Lead Pad Cast Stock on A4

Vacuum Vessel Pad on B3

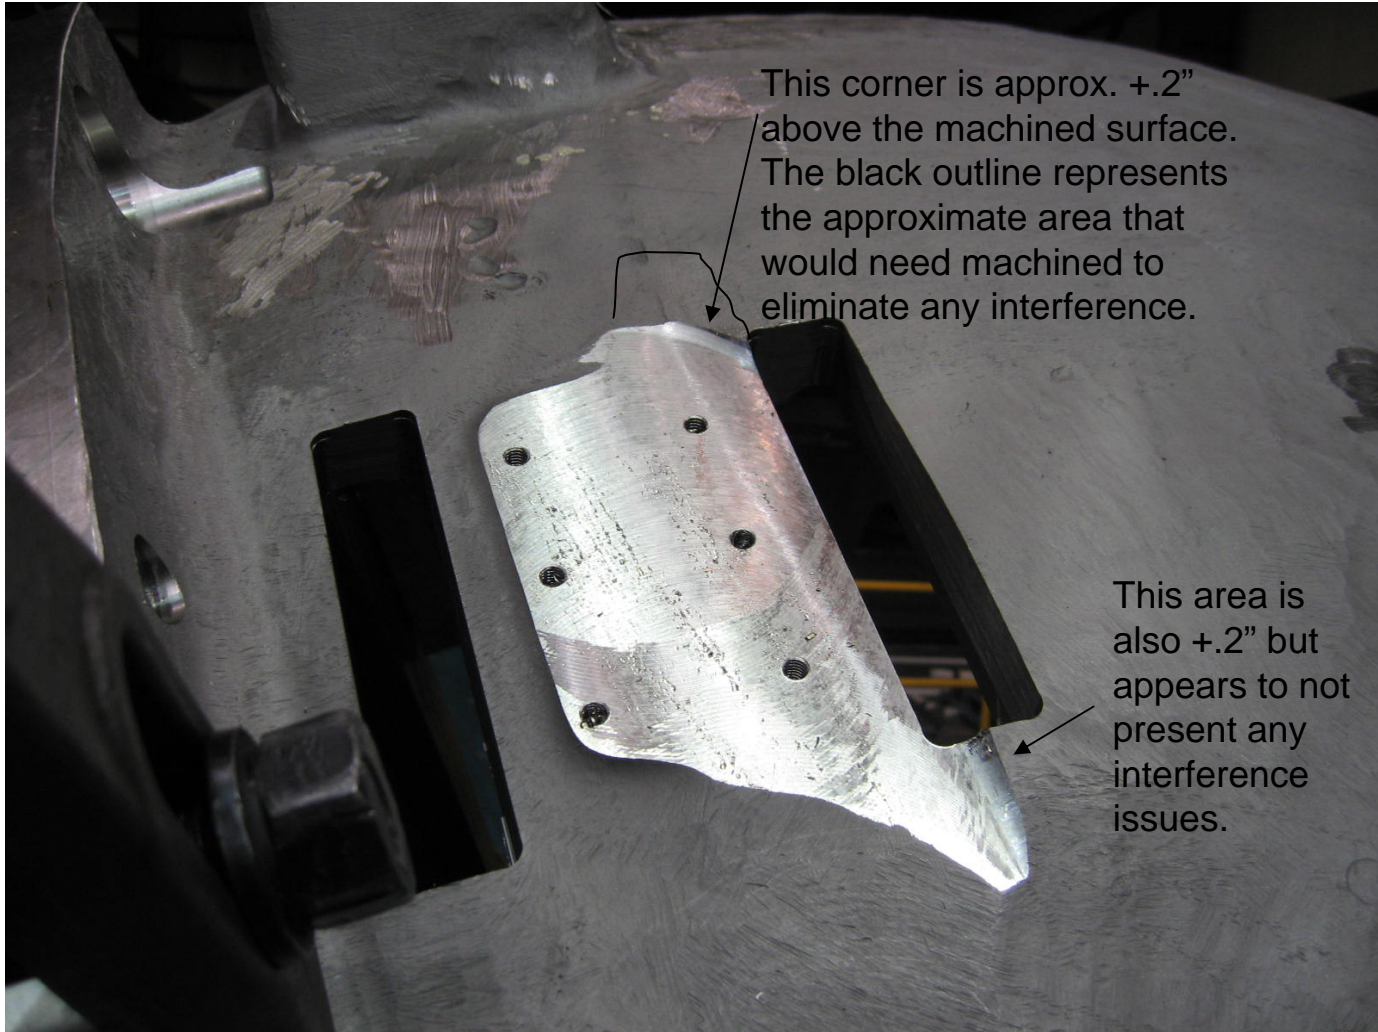
The 3 hole pattern would be shifted .25" (parallel to the datum E flange) to accommodate the hole circled in the pattern above.
